BZA Packet

MEETING AGENDA
CITY OF MOUNTAIN BROOK
BOARD OF ZONING ADJUSTMENT
AUGUST 15, 2016
PRE-MEETING: (ROOM A106) 4:30 P.M.
REGULAR MEETING: (ROOM A108) 5:00 P.M.
CITY HALL, 56 CHURCH STREET, MOUNTAIN BROOK, AL 35213

Report to the Board of Zoning Adjustment

Report to the Board of Zoning Adjustment

LOT 7 - AMHERST CIRCLE

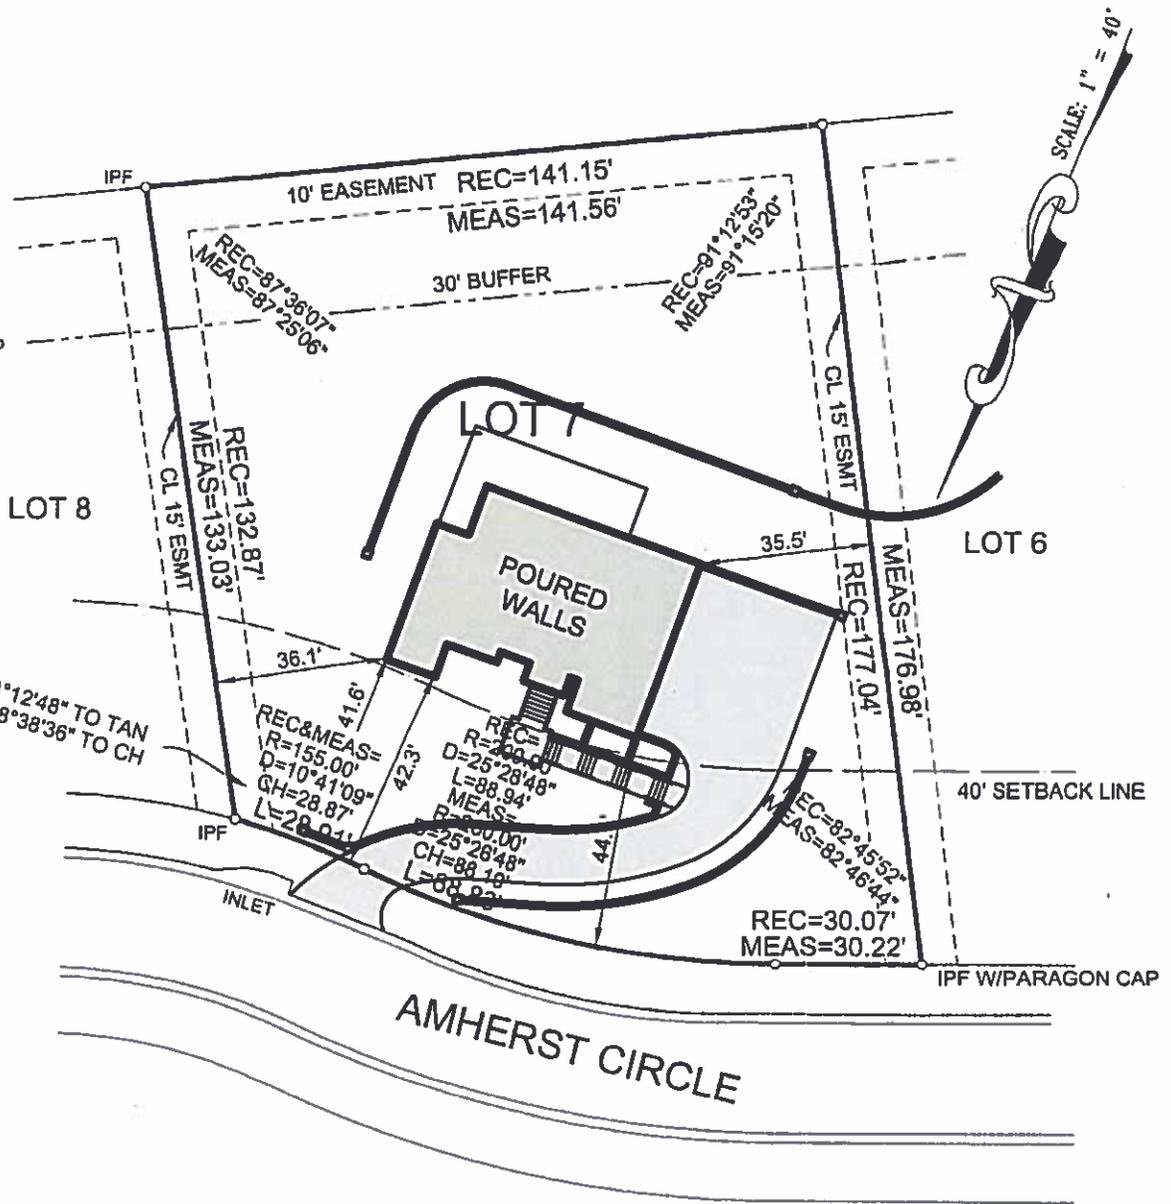
Questions have been raised by neighboring property owners as to how the proposed retaining walls will be buffered with landscaping, and what sort of landscaping is proposed in the front setback; also, how landscaping could be maintained on such a steep slope.

Should the Board be inclined to approve the retaining walls, it may be prudent to ensure a proper landscape buffer to soften the effect of high walls from the street view. The top of the rail (between 35-40 feet from the front property line) is to be approximately 29 feet above the street grade at the front property line.

SITE PLAN/ GRADING PLAN LOT 7 - AMHERST CIRCLE

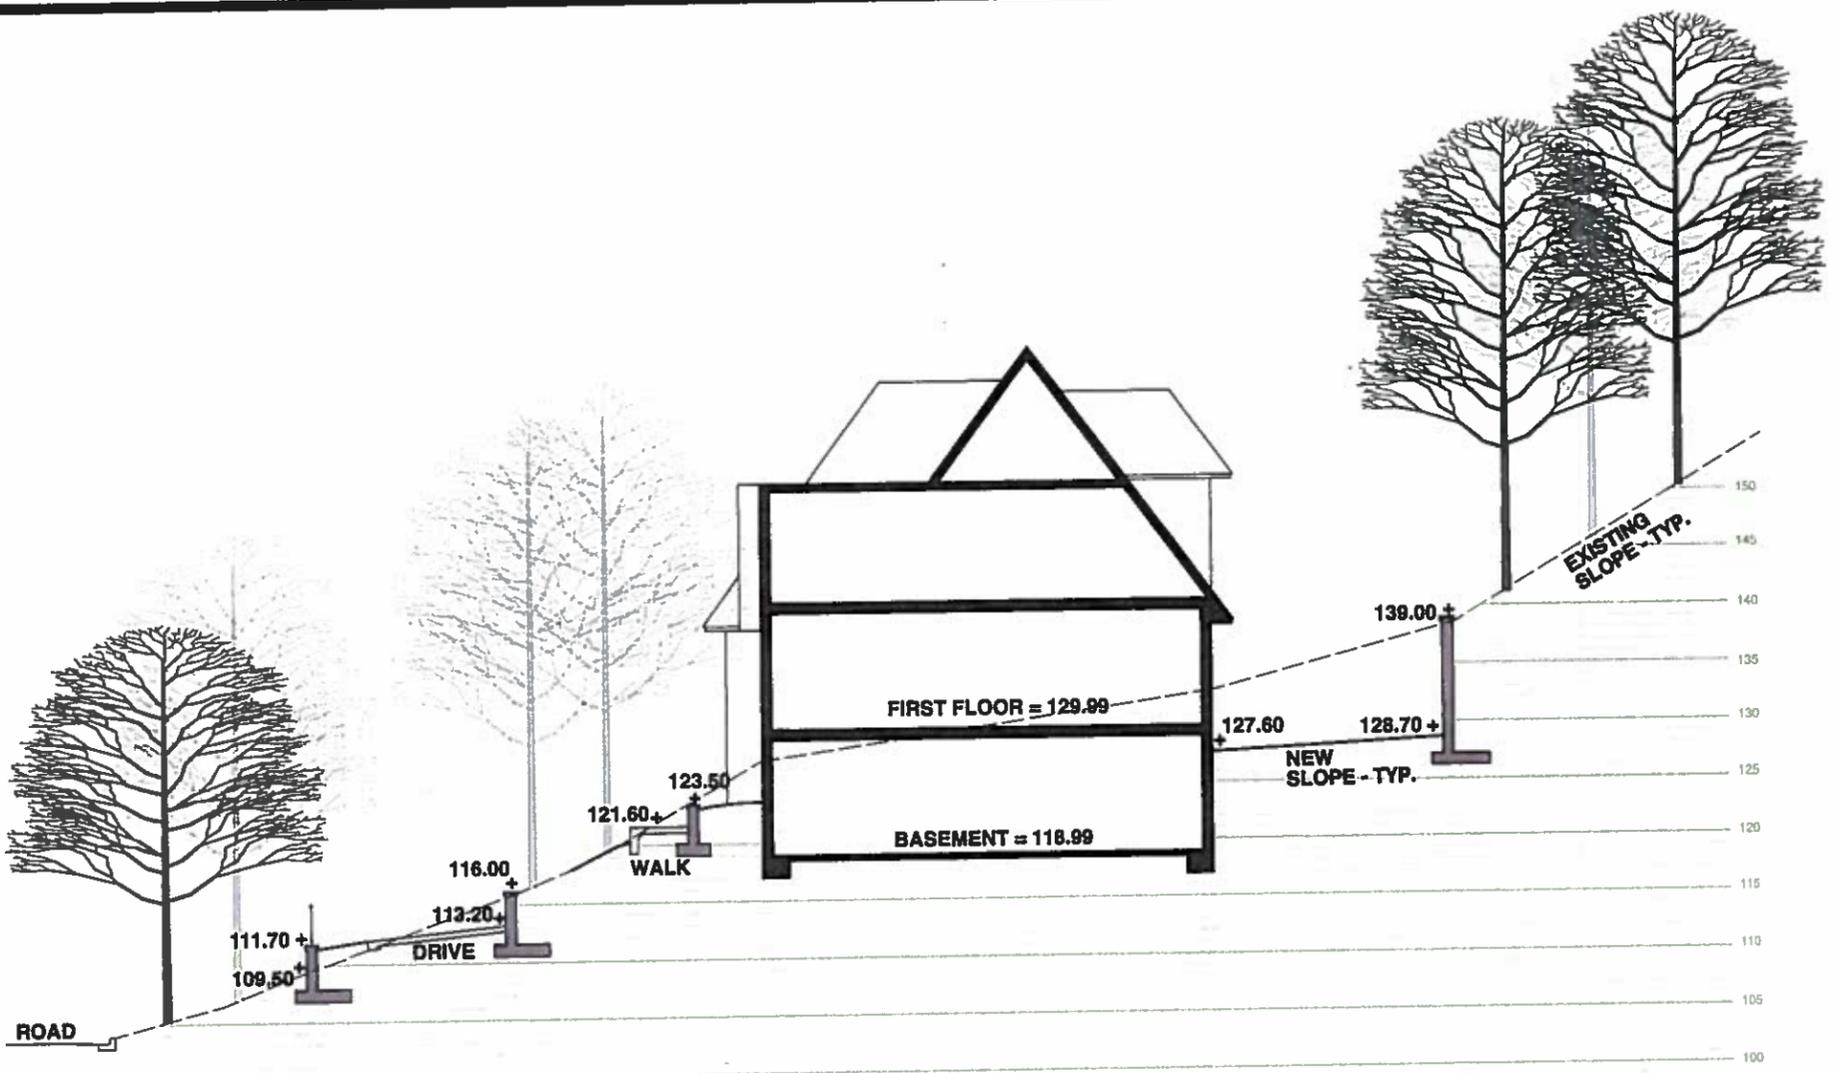
The hardship in this case is topography. As may be seen on the attached original topography map (Site/Grading Plan) the elevation at the front property line is 107 and is 150 at the rear retaining wall, for an overall grade change of 43 feet within the first 110 feet of the lot.

The proposal involves retaining walls and related improvements for the driveway and front entrance stairs and landing. Proposed retaining wall heights are shown in circles, which range from 1 foot to 6.4 feet above original grade within the 40-foot front setback. Circles highlighted in yellow reflect the portions of the wall that are above the 4-foot height limit (ranging from 4.25 feet to 6.4 feet). In addition a 3-foot high wrought iron guard rail is proposed atop the 6.4 foot wall at the stair and landing, for a total height of 9.4 feet in lieu of the allowed 4 feet. Refer to attached Sections 7A and 7B to see the grade and proposed improvements in side view.

LOT 6 - AMHERST CIRCLE

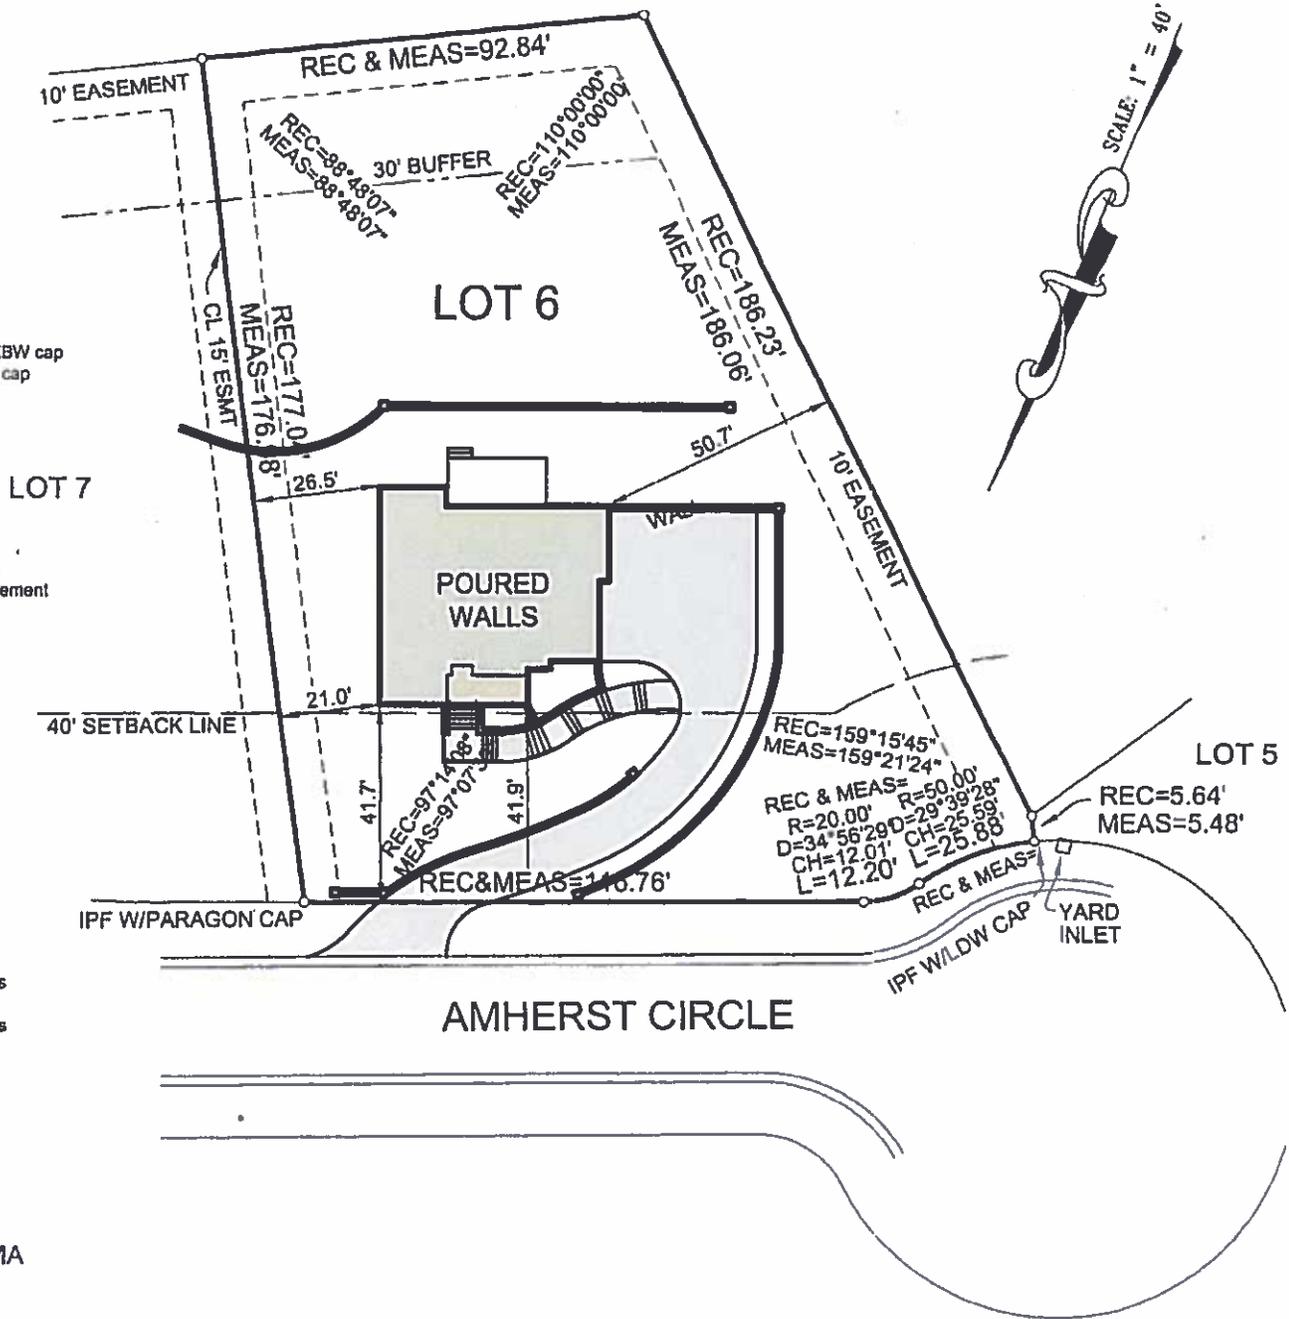
Questions have been raised by neighboring property owners as to how the proposed retaining walls will be buffered with landscaping, and what sort of landscaping is proposed in the front setback; also, how landscaping could be maintained on such a steep slope.

Should the Board be inclined to approve the retaining walls, it may be prudent to ensure a proper landscape buffer to soften the effect of high walls from the street view. The top of the rail (between 30-40 feet from the front property line) is to be approximately 36 feet above the street grade at the front property line.

SITE PLAN/ GRADING PLAN LOT 6 - AMHERST CIRCLE

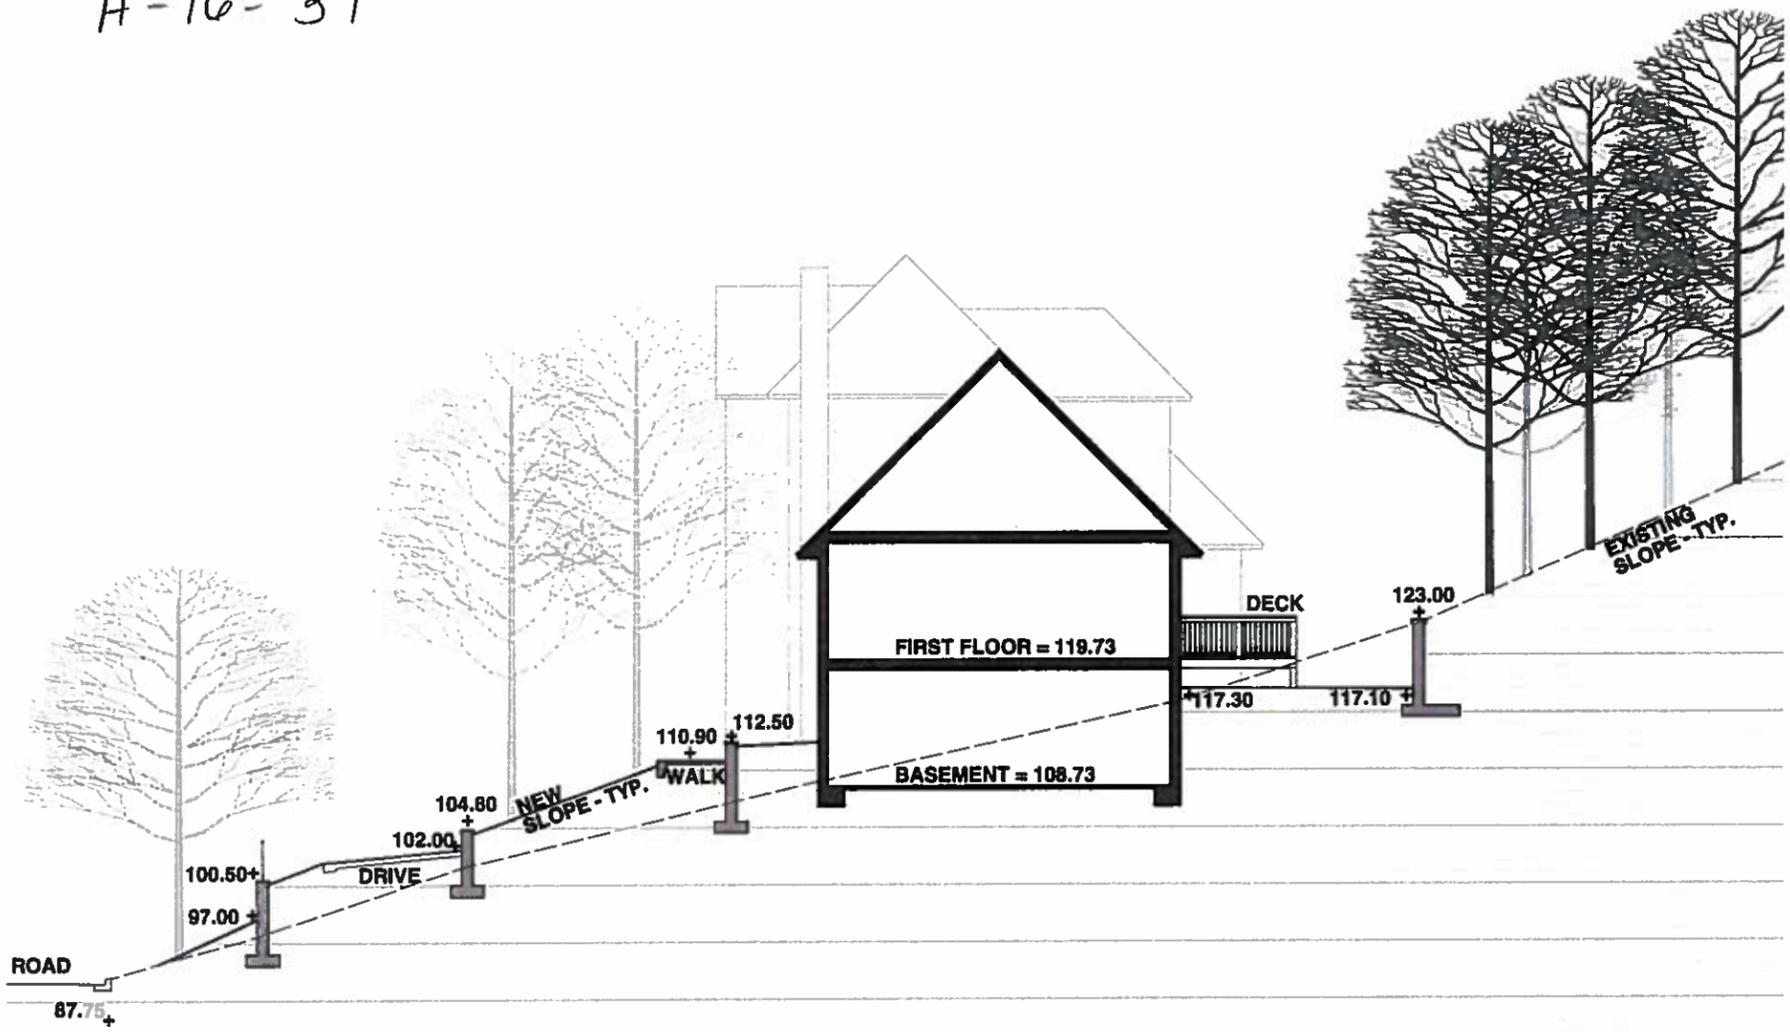
The hardship in this case is topography. As may be seen on the attached original topography map (Site/Grading Plan) the elevation at the front property line is 90 and is 130 at the rear retaining wall, for an overall grade change of 40 feet within the first 100 feet of the lot.

The proposal involves retaining walls and related improvements for the driveway and front entrance stairs and landing. Proposed retaining wall heights are shown in circles, which range from 3 feet to 6.4 feet above original grade within the 40-foot front setback. Circles highlighted in yellow reflect the portions of the wall that are above the 4-foot height limit (ranging from 4.5 feet to 6.4 feet). In addition a 3-foot high wrought iron guard rail is proposed atop the 6.4 foot wall at the stair and landing, for a total height of 9.4 feet in lieu of the allowed 4 feet. Refer to attached Sections 6A and 6B to see the grade and proposed improvements in side view.
